BUILDING 1 - HEAT PUMP -22- (ROOM 1122)

PROJECT	ARTS
DATE	3-31-10
SCALE	NA
DWG. BY	P. BRODERICK
CHKD. BY

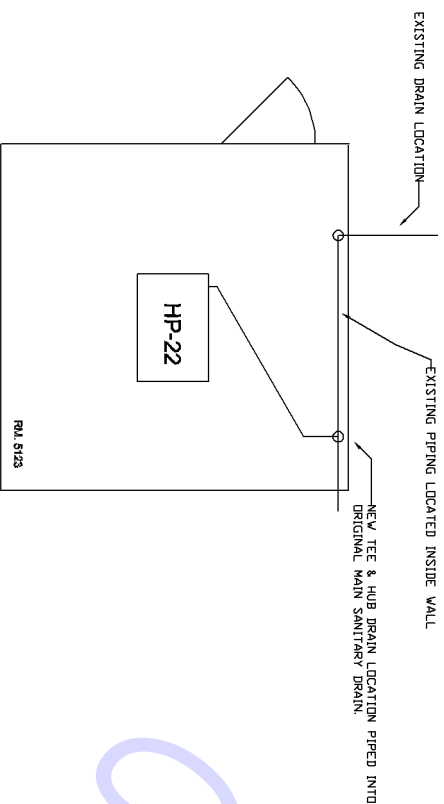
THERE IS NO ORIGINAL LOCATION FOR THE CONDENSATE DRAIN IN THE BLOCK WALL BECAUSE THIS WAS AN ADDED UNIT IN THIS BUILDING.

TO PROVIDE CONDENSATE DRAINAGE PIPING IN THIS LOCATION:

IT IS PROPOSED TO CUT IN A TEE AT THE SANITARY VENT FOR THE P-6 FEATURE IN THE ADJACENT ROOM 1123. ONE SIDE OF THE WILL COME OUT IN ROOM 1122 AND HAVE A P-TRAP IN THE LOCATION WHERE CONDENSATE DRAIN FROM HEAT PUMP WILL THE INTO TRAP.

BUILDING 5 - HEAT PUMP -22- (ROOM 5123)

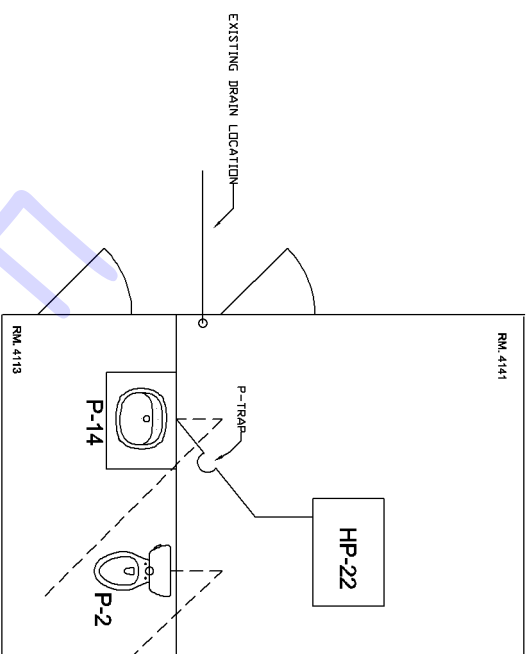
AS AN ALTERNATE TO REMOVING EXCESSIVE BLOCK WALL TO LOWER EXISTING CONDENSATE DRAIN: WE WOULD FIRST CAP OFF THE EXISTING HIGH DRAIN LOCATION IN THE BLOCK WALL.

IN THIS CASE, WE WOULD CUT OUT BLOCK IN A SMALL AREA ON THE OTHER SIDE OF WALL THAT CONTAINS ORIGINAL CONDENSATE LINE. WE WOULD INSTALL A TEE IN THE EXISTING LINE AT THIS NEW LOCATION AND CONDENSATE PIPING FROM HEAT PUMP TO THE NEW TEE IN THE EXISTING DRAIN LINE. WE WOULD PROPOSE TO CAP OFF EXISTING HIGHER HUB DRAIN.

BUILDING 4 - HEAT PUMP -22- (ROOM 4141)

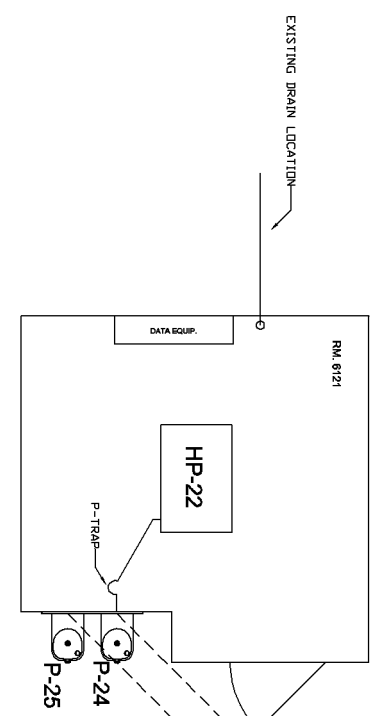
AS AN ALTERNATE TO REMOVING EXCESSIVE BLOCK WALL TO LOWER EXISTING CONDENSATE DRAIN:

IN THIS CASE, WE DO NOT RECOMMEND LOWERING THE EXISTING WALL DRAIN AT LOCATION INDICATED DUE TO THE CLOSE PROXIMITY OF THE DOOR JAMB TO THE CORNER. IF BLOCK IS CHIPPED OUT AND REMOVED, DAMAGE TO THE ENTIRE DOOR UNIT IS PROBABLE.

WE WOULD FIRST CAP OFF THE EXISTING DRAIN LOCATION IN THE BLOCK WALL.

IT IS PROPOSED TO CUT IN A TEE AT THE SANITARY VENT FOR THE P-14 FEATURE IN THE ADJACENT ROOM 4113. ONE SIDE OF THE WILL COME OUT IN ROOM 4141 AND HAVE A P-TRAP IN THE LOCATION WHERE CONDENSATE DRAIN FROM HEAT PUMP WILL THE INTO TRAP.
